Please attend a meeting of the PLANNING COMMITTEE to be held on MONDAY, 21 FEBRUARY 2022 at 1.00 pm in the Council Chamber, Town Hall, Rose Hill, Chesterfield S40 1LP, the agenda for which is set out below.

## **PLANNING COMMITTEE**

COMMITTEE/SUB	Planning Committee
DATE OF MEETING	21 <sup>st</sup> February 2022
TITLE	DETERMINATION OF PLANNING APPLICATIONS
PUBLICITY	*For Publication
CONTENTS SUMMARY	See attached index
RECOMMENDATIONS	See attached reports
LIST OF BACKGROUND PAPERS	For each of the attached reports, the background papers consist of the file specified in the top right hand corner on the front page of the report. Those background papers on the file which do not disclose exempt or confidential information are open to public inspection at the office of the Development Management and Conservation Manager – Planning Services. Additional background papers (if any) will be separately listed in the report.

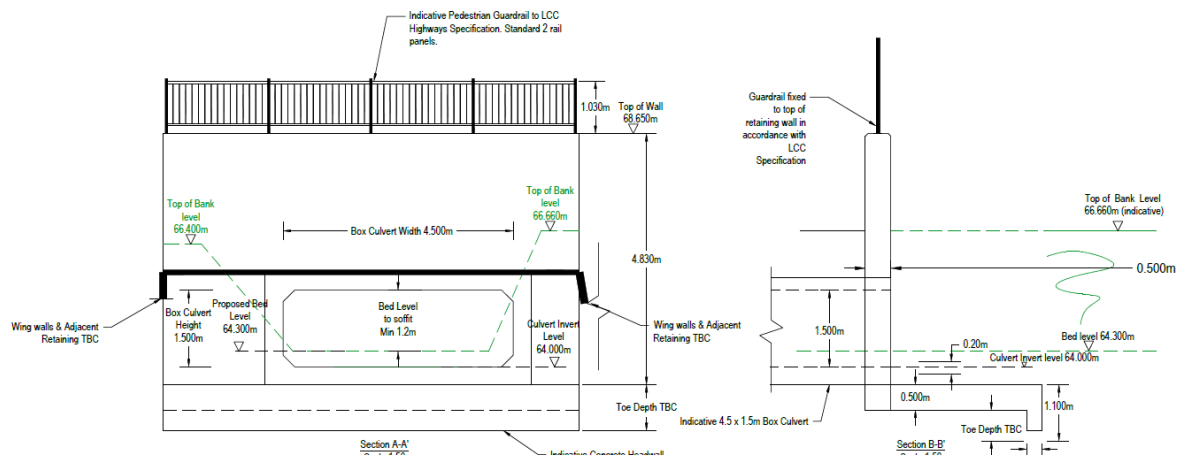
*3) The developer should clearly indicate on plans, how cyclists will get on and off the shared cycleways.*

The shared routes for pedestrians and cycles are show n to be 3m wide and are largely separated from the roadway by a planted verge.

The cycle routes are now largely continuous and where they veer from the site the route is clear.

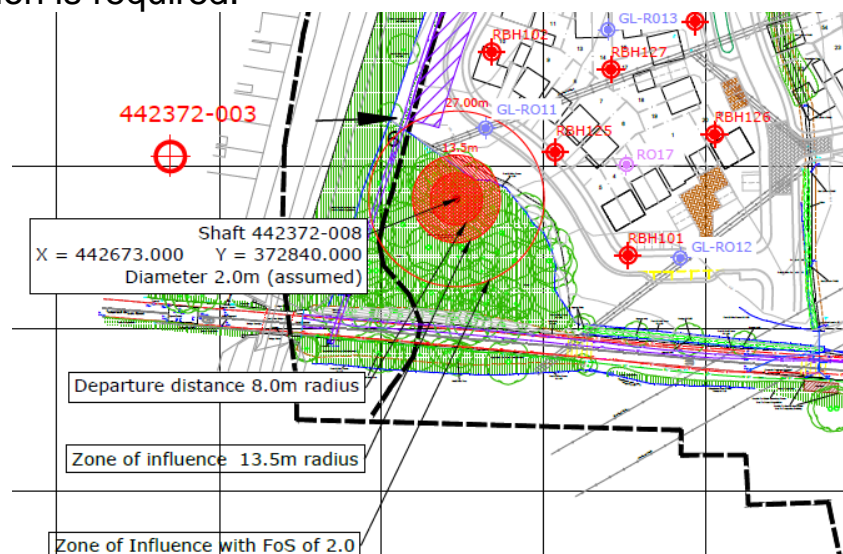
*We are pleased to see that consideration has been given to the potential risks posed by the recorded mine entry and that mitigation measures are now proposed. We would expect the geogrid recommended for the access road to be installed as part of the construction works for this element of the development. In respect of the 2m high fencing proposed around the zone of influence for the mine entry we would expect this to be installed on site prior to the first occupation of the development.*

*The fence should be retained in situ thereafter to prevent unauthorised access to this area. You may consider it prudent to impose planning conditions in respect of the above.*

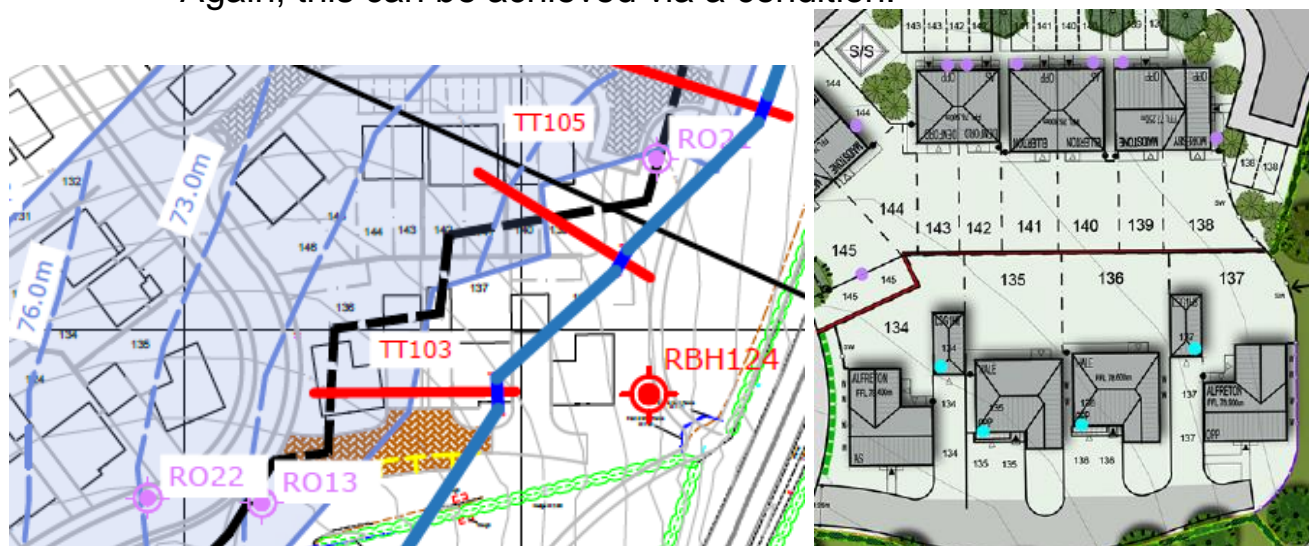
- 5.11.5 It is also apparent that the zone of influence relating to this shaft increases risk at the point of the roadway in this area of the site and that

works will be required to ensure safety in this area. Again this detail needs to be secured via a further condition.

- 5.11.6 It is also apparent that the opencast highwall will impact on plot 137 and that foundation design for that specific plot needs further consideration. Again, this can be achieved via a condition.
